RE: Comments from the City of Burnsville
Xcel Energy Black Dog to Savage 115 kV Transmission Line Project
PUC Docket No. TL-11-795

XCEL ENERGY TRANSMISSION LINE REBUILD/
118TH STREET IMPROVEMENTS
PROPOSED TYPICAL SECTIONS

ATTACHMENT "A"

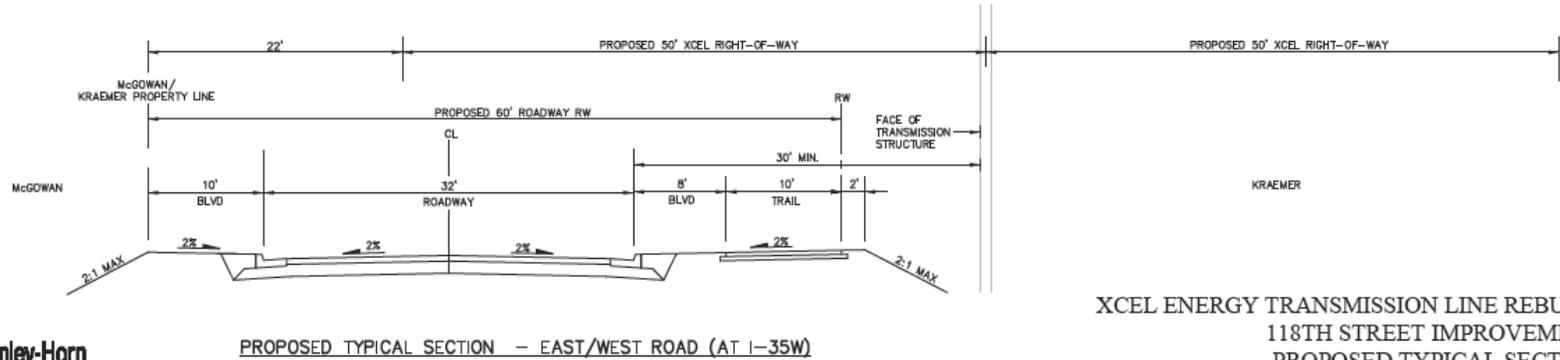
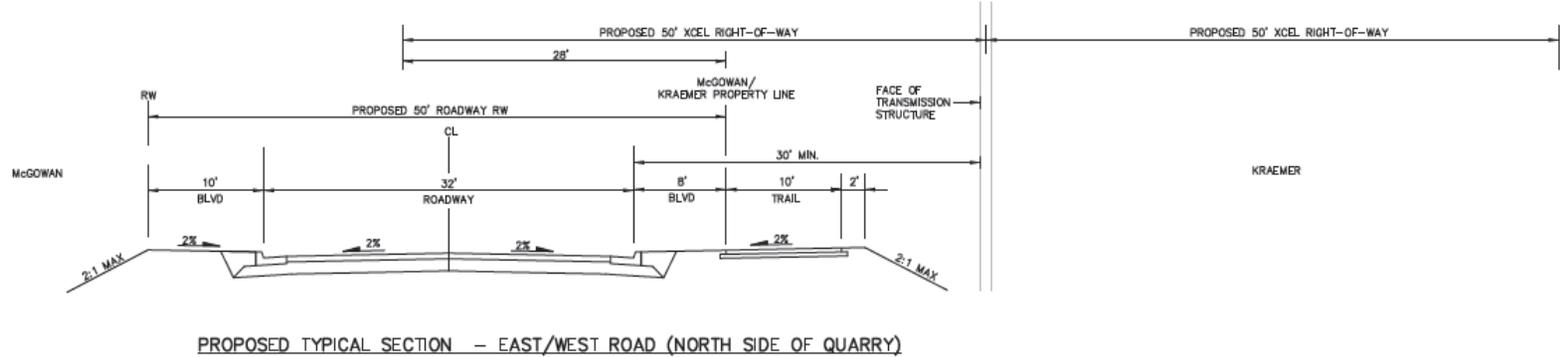
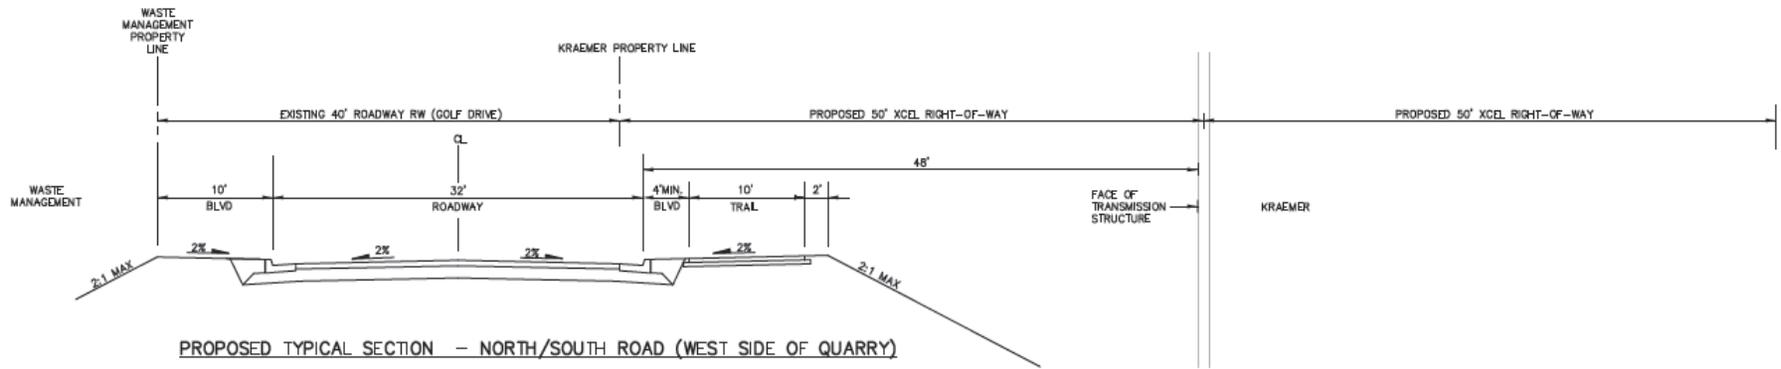
The City has taken the proposed pole locations and field-located them in relation to the future roadway facilities. The proposed poles need to be at least 50 feet east of the western KMM property line on the proposed north-south road. If they are located closer than that, retaining walls will be required to build the roadway unless additional fill can be placed against the poles.

Typical sections have been created to illustrate the future road location in relation to the power poles (see Attachment A). The right-of-way and pole locations in this corridor are of great concern to the City.
